**ADDENDUM NO. 3**

**Engineer:**  
Parametrix  
60 Washington Avenue, Suite 390  
Bremerton, WA 98337

**LAGOONS 2 AND 3 DREDGING AND DEWATERING**

**ADDENDUM NO. 3**  
**LAGOONS 2 AND 3 DREDGING AND DEWATERING**  
**MODIFICATIONS TO BIDDING DOCUMENTS**

**D1**

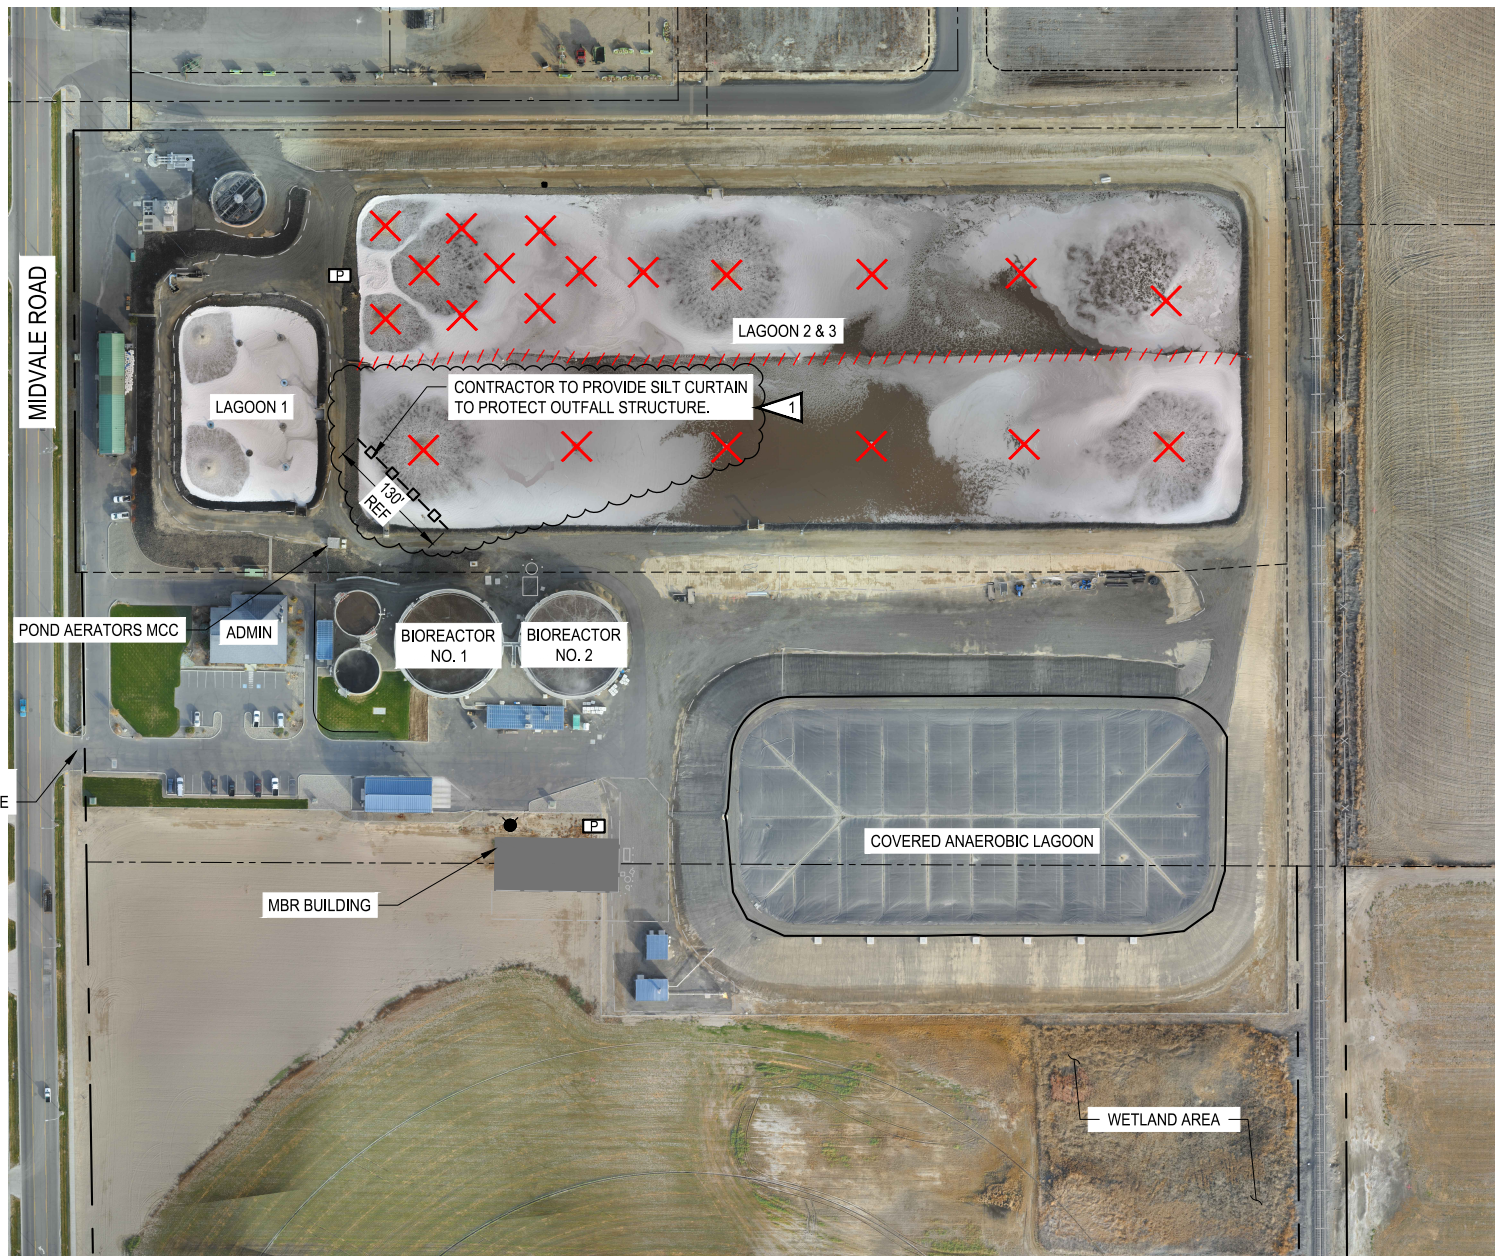
**Sheet D1** - Addition of silt curtain to protect outfall structure. See attached.
